Technical Bulletin

01 14 05 February 21, 2014 2019434 Supersedes T.B. V011206 dated March 14, 2012 to correct Technical Diagnosis labor operation coding in the warranty table.

MIL ON, DTCs P0325 or P0327 Stored in ECM Fault Memory

Figure 1

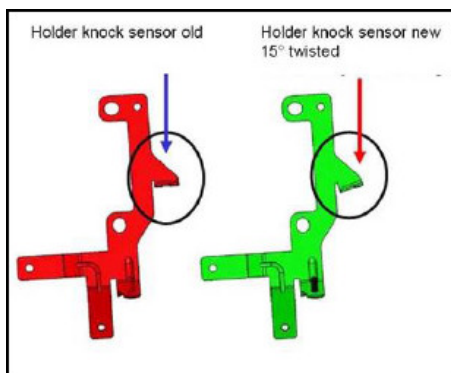
1. Replace knock sensor -G61- with wiring harness 03H 905 377A.
2. Tighten the mounting bolt of knock sensors to 20 Nm (177 in. lbs.).

Figure 2

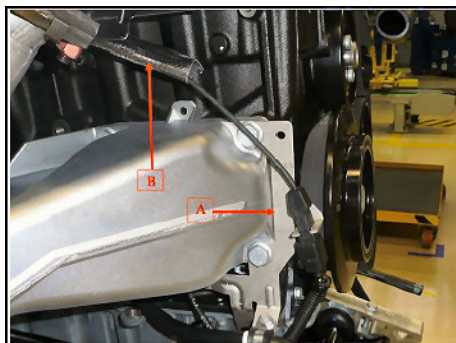
- Inspect whether or not knock sensor bracket Part No. 03H 971 501 D (the new knock sensor bracket that is twisted 15°) is installed.

If the old knock sensor bracket 03H 971 501 A is installed:

- Replace with the new bracket Part No. 03H 971 501 D (Figure 2, inset A).

Figure 3

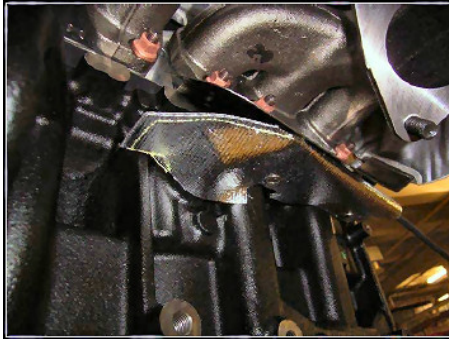
- Install extra heat insulation Part No. 03H 971 461 as shown in Figure 3.
